**Quanta Computer Inc.**  
**PROJECT : NL-6**

Size	Document Number	Rev
	<b>Google Debug</b>	1A
Date:	Friday, February 21, 2014	Sheet 18 of 40

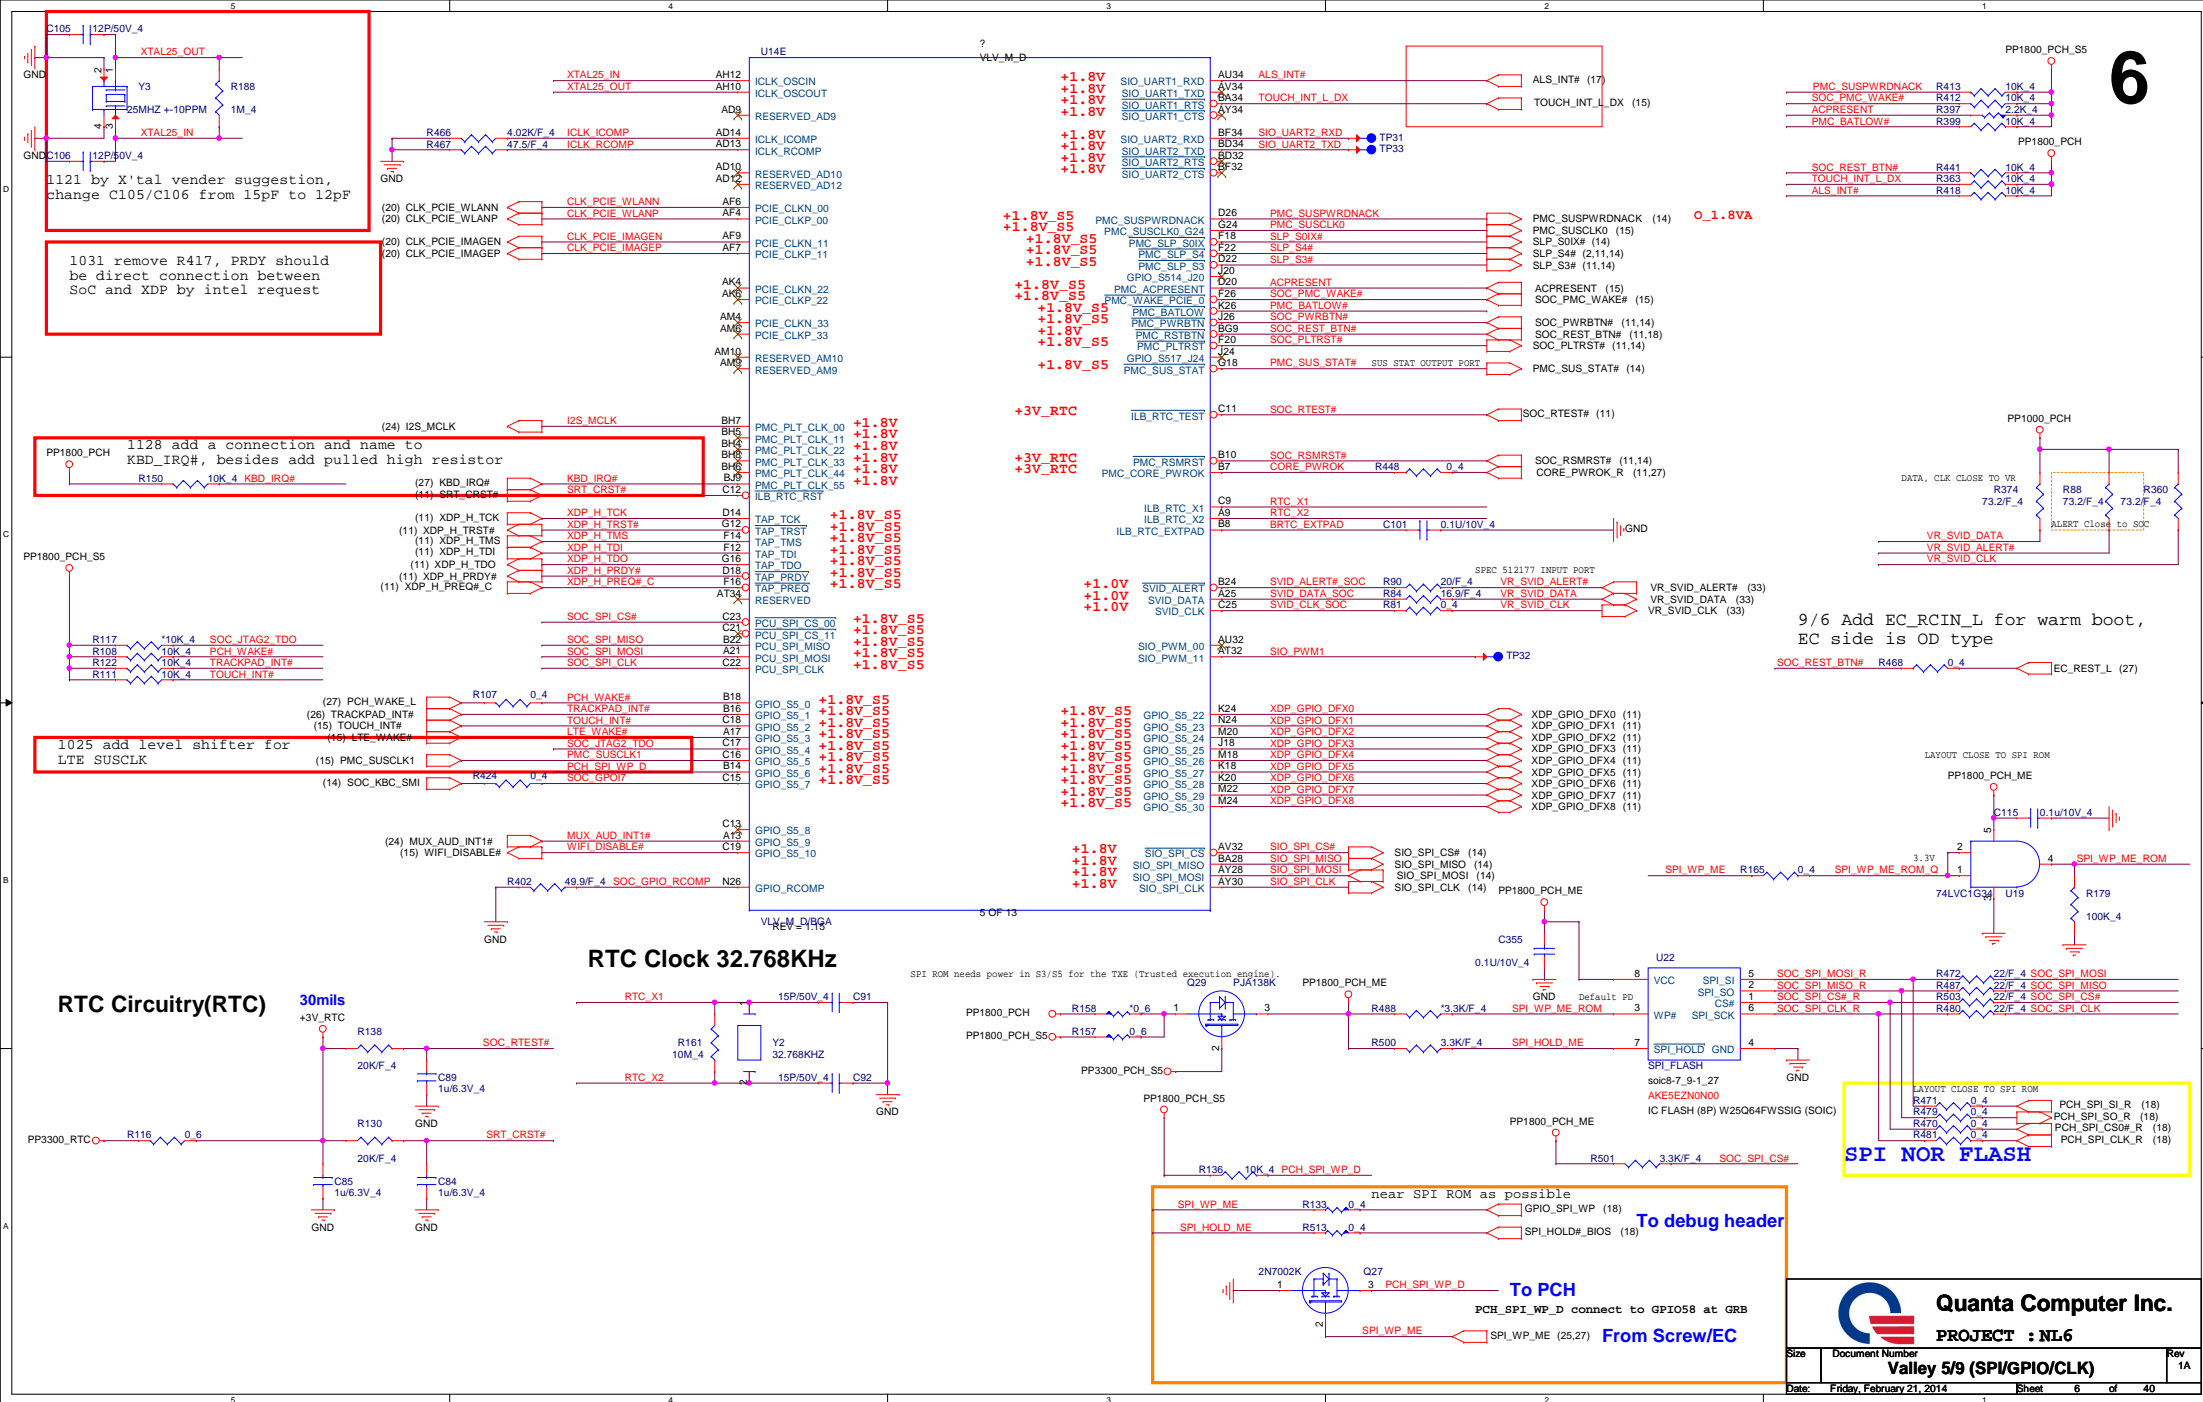
```
1029 unstuff R128, using SoC internal PU
1029 unstuff R372, using SoC internal PU
1115 stuff R372, system can't boot if un-stuff R372 on
protol.5 board, need intel double confirm before proto2
```

1029 unstuff R386, using SoC internal PU  
 1115 stuff R386, it is required for eDP

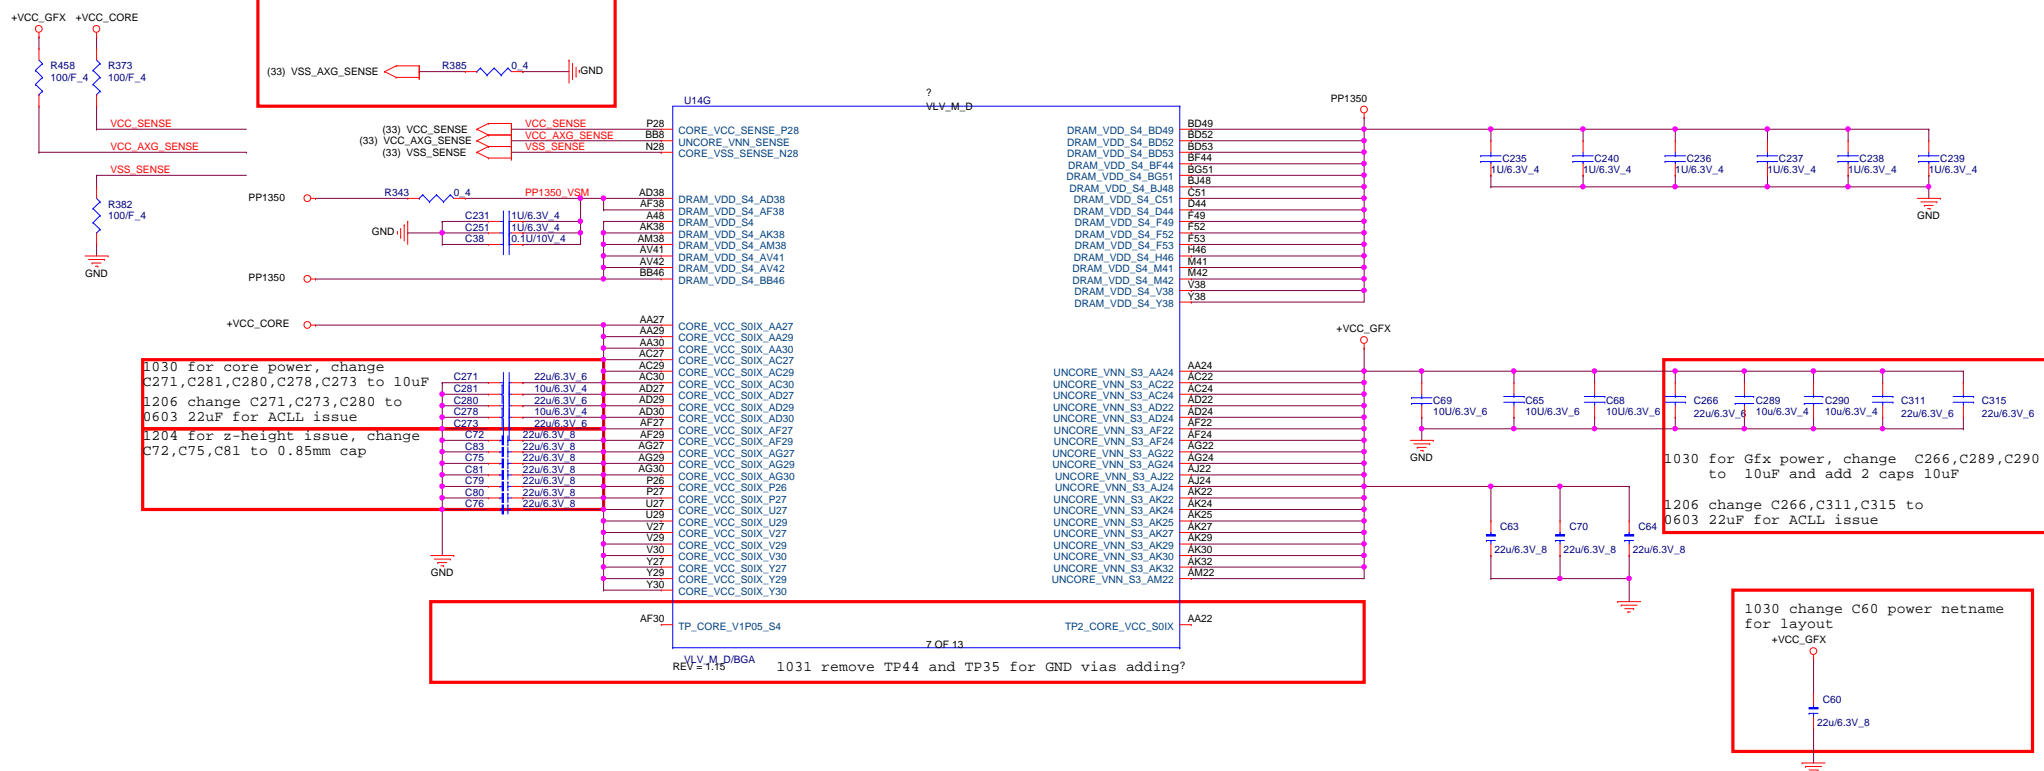
1101 add option BOM R446,R449 for EC CLK for power saving by Intel request

# PWRON SEQUENCE

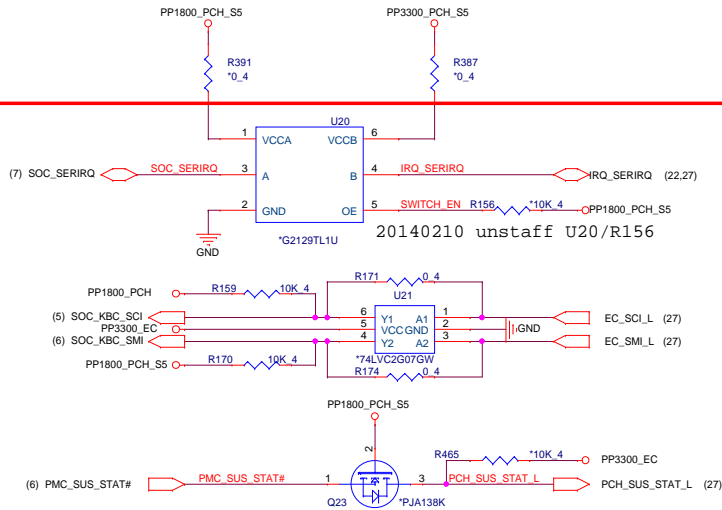
9/6 EC table says SERIRQ is OD pin, reserve for debugging  
 1128 remove R166, because SERIRQ of TPM needs 3V  
 1128 reserve 0 ohm R387/R391 on VCCA and VCCB for debugging  
 20140210 unstuff R387/R391

# PWRON SEQUENCE

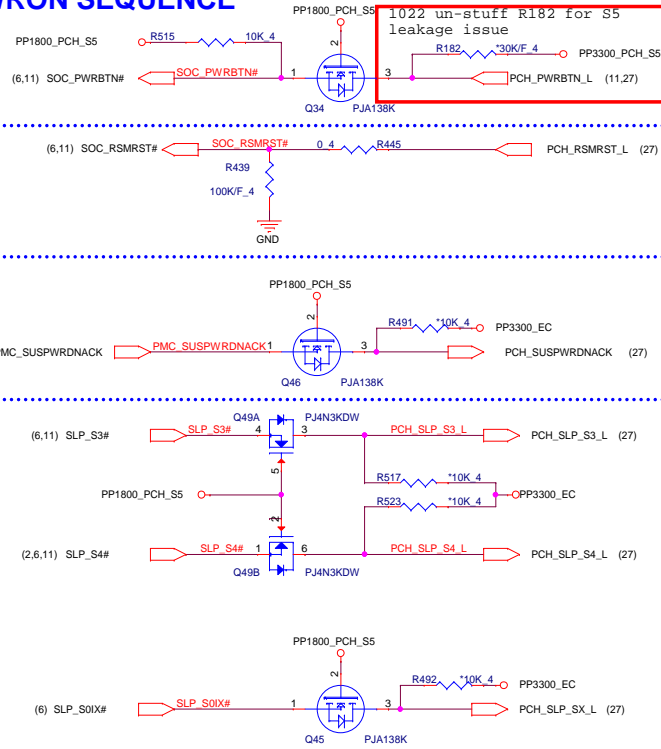
9/6 Need check MOSFET switching speed>15MHz

# GOOGLE Debug Port(MPC)

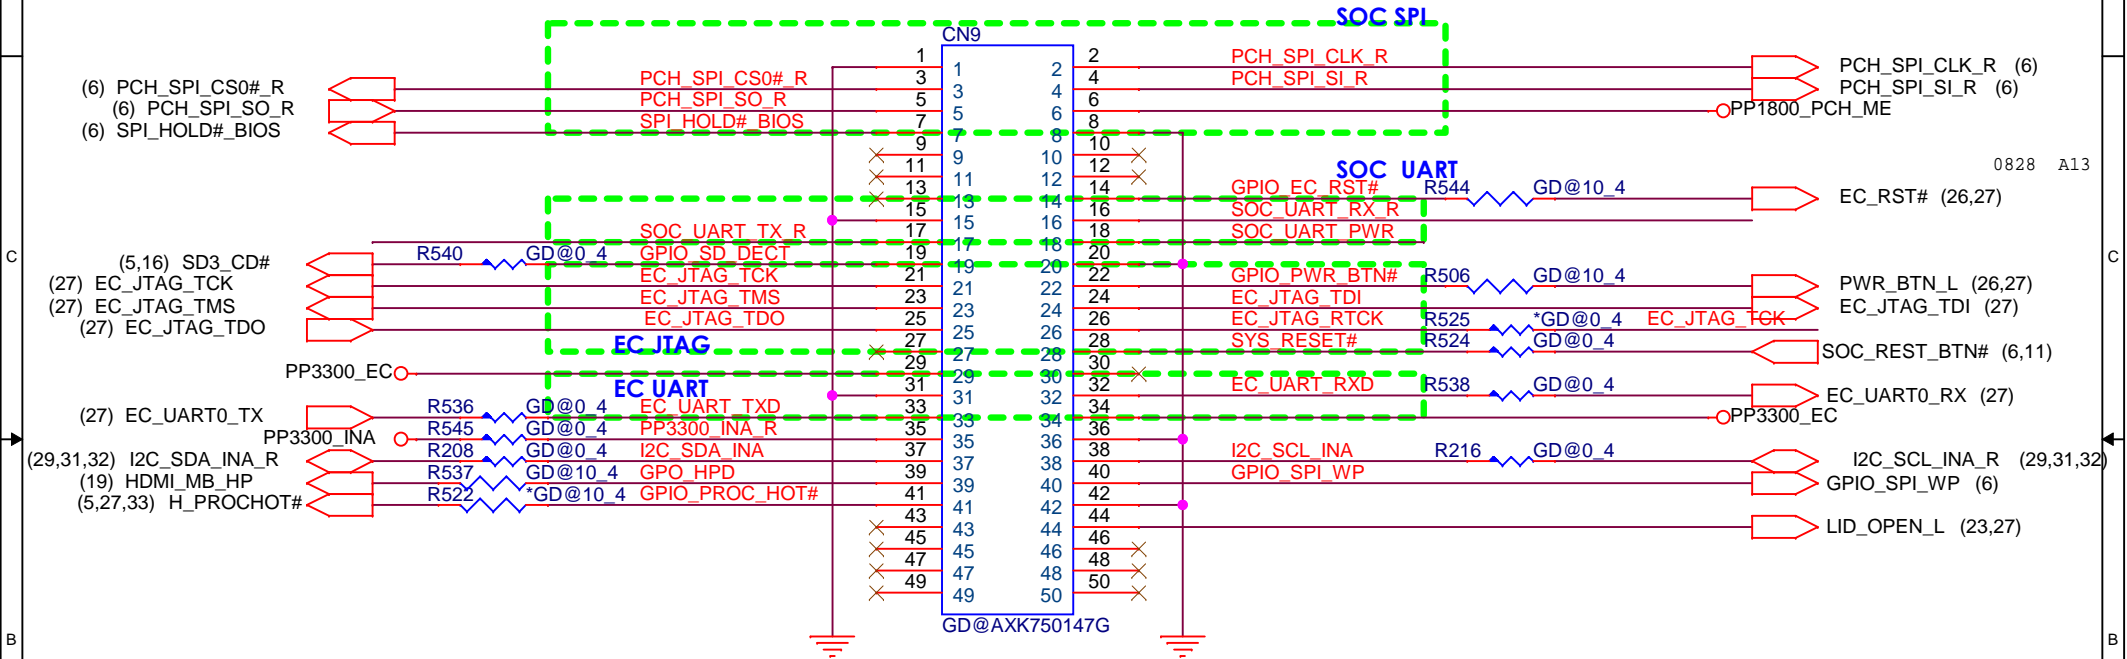
## 1021 change footprint and PN

9/6 using optional instead of level shifted, default is from SoC

9/13 add pull up

## HEADPHONE/Mic combo(ADO)

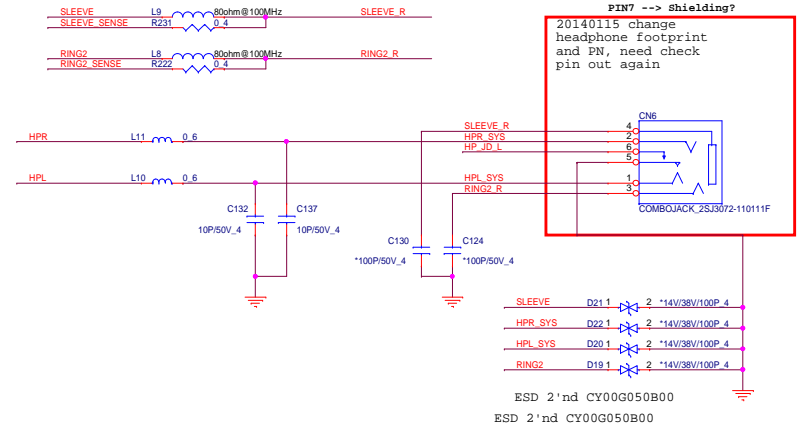
20140115 change  
headphone footprint  
and PH, need check  
pin out again

## 20140127 Change KB CONN for ME require

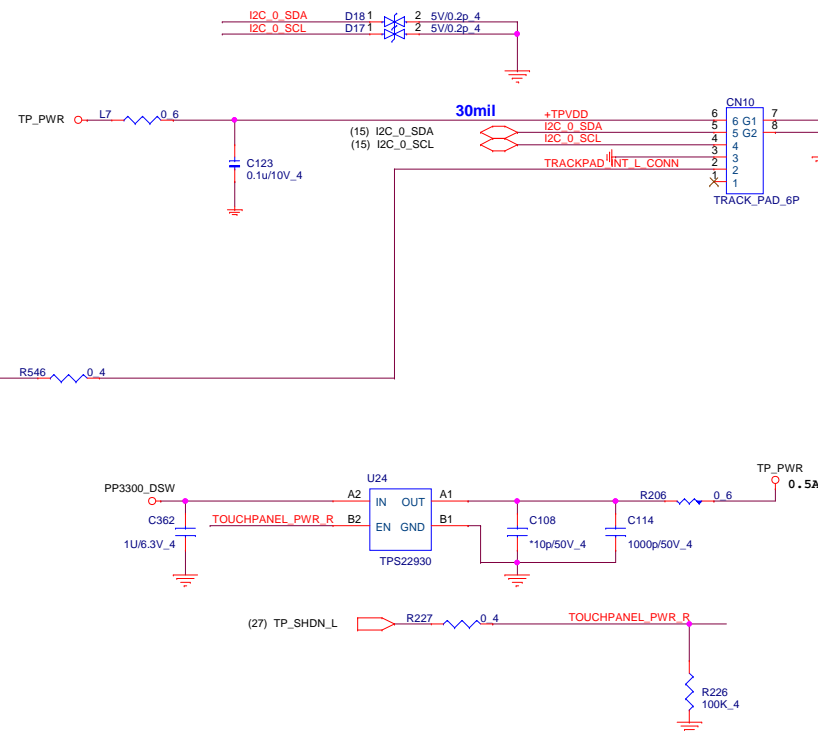
5/15 modify, PU already at EC side

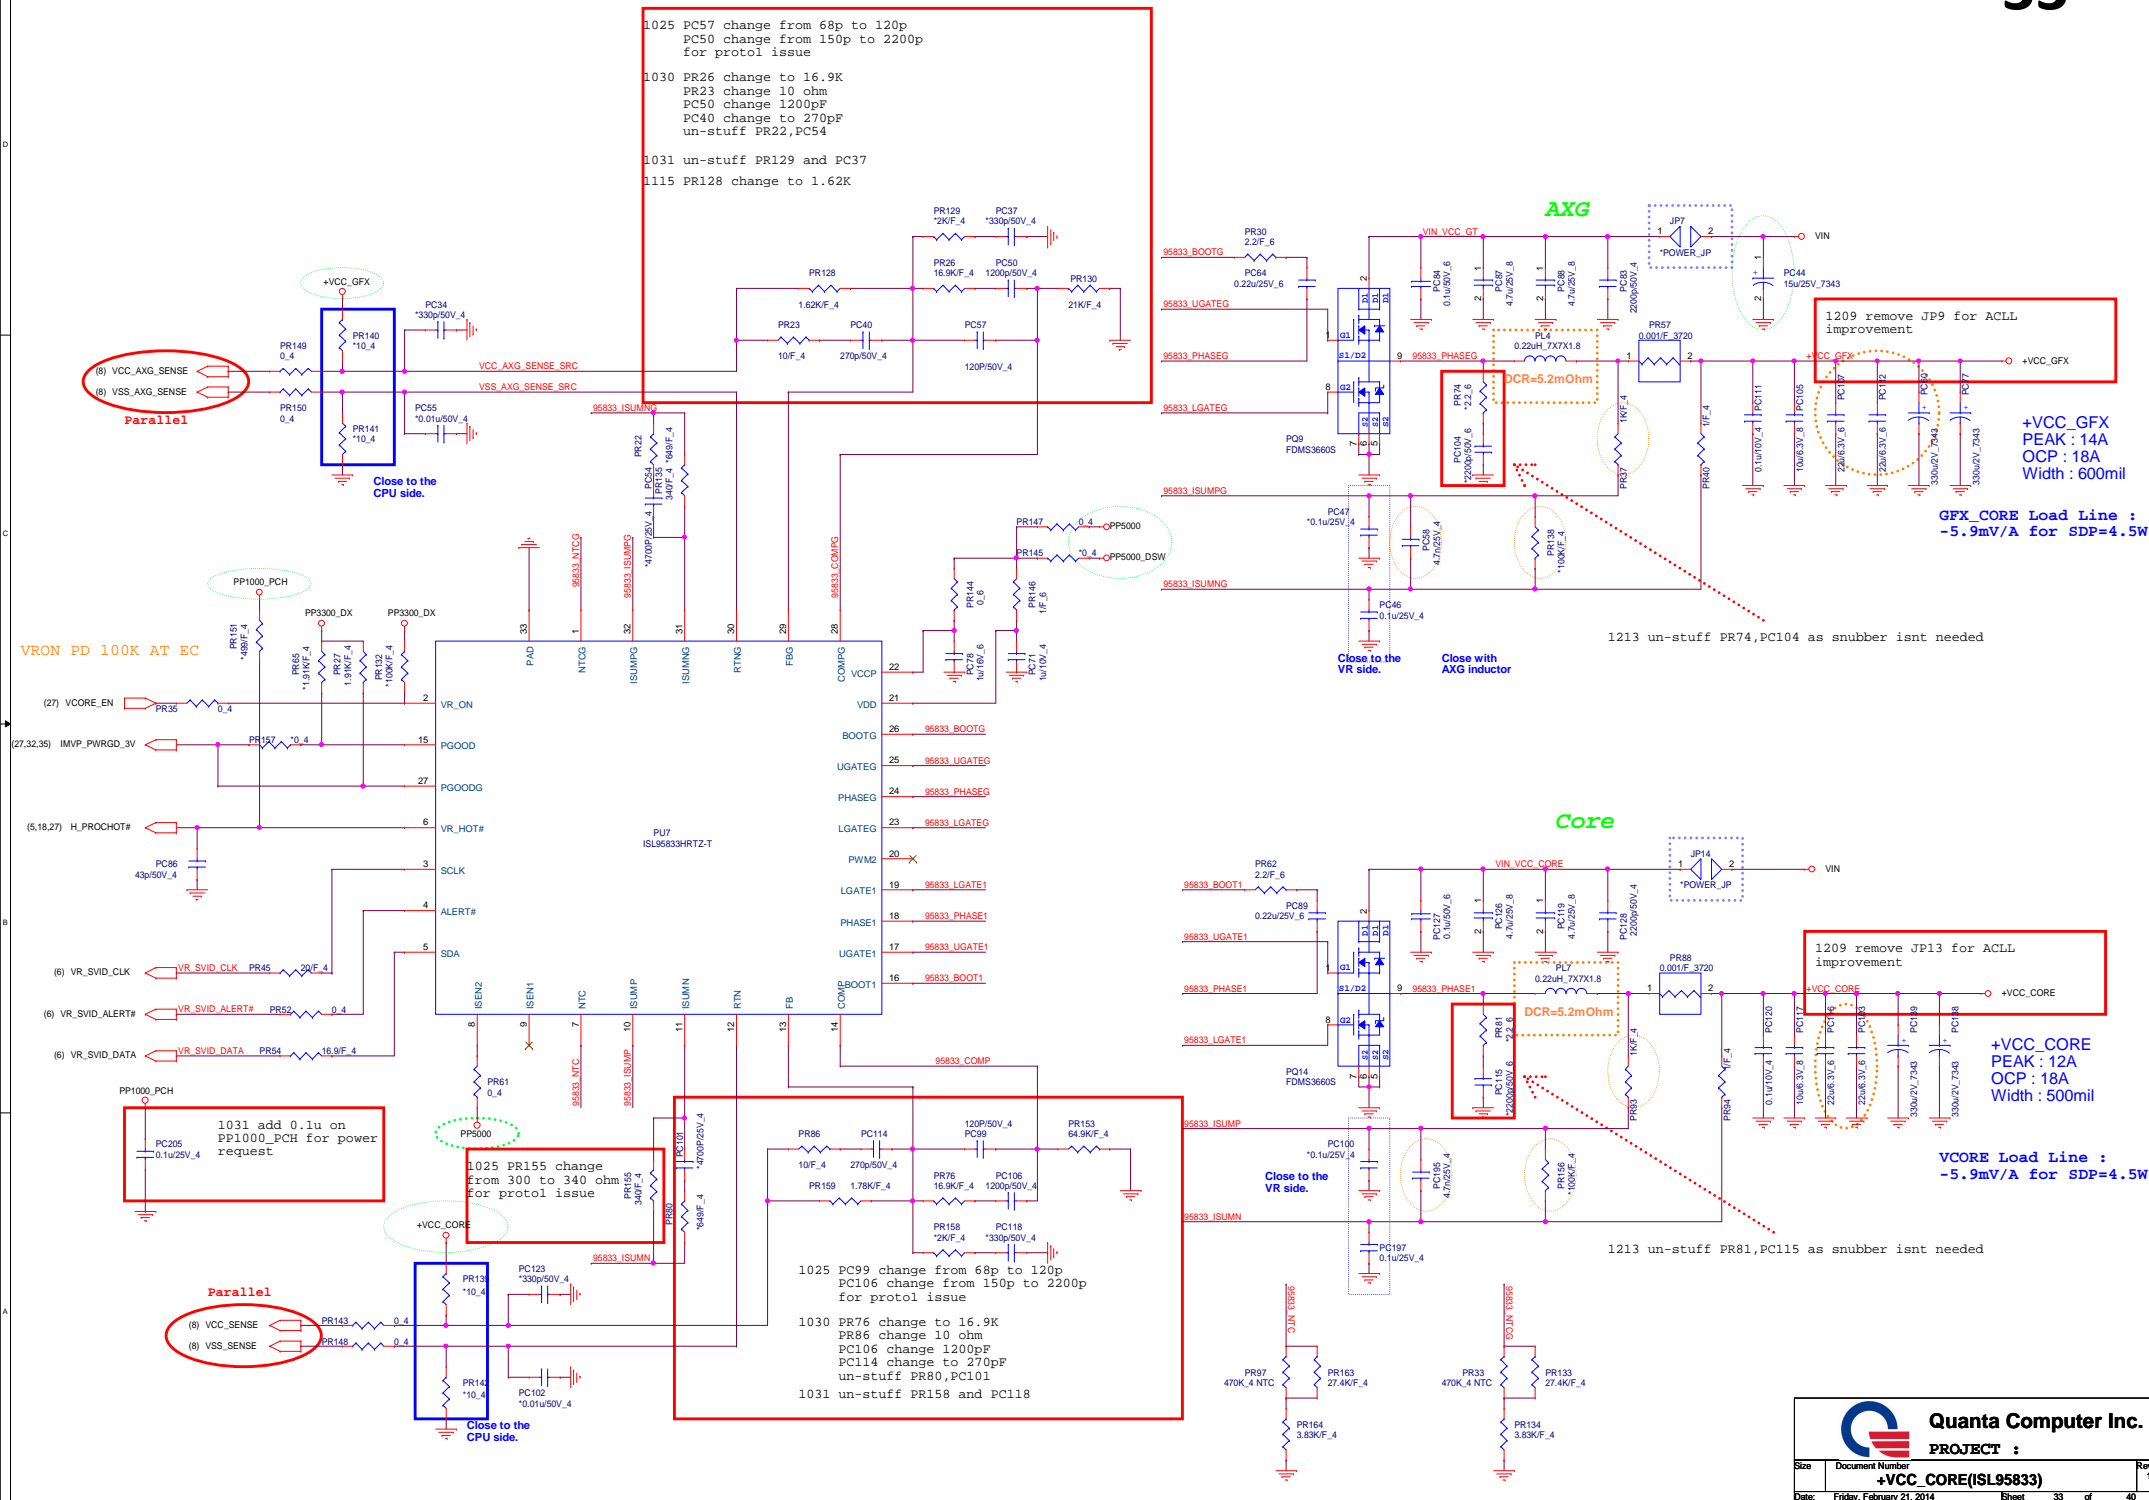
1129 PP1000\_PCH changes from convert to power MOSFET type for power efficiency improvement
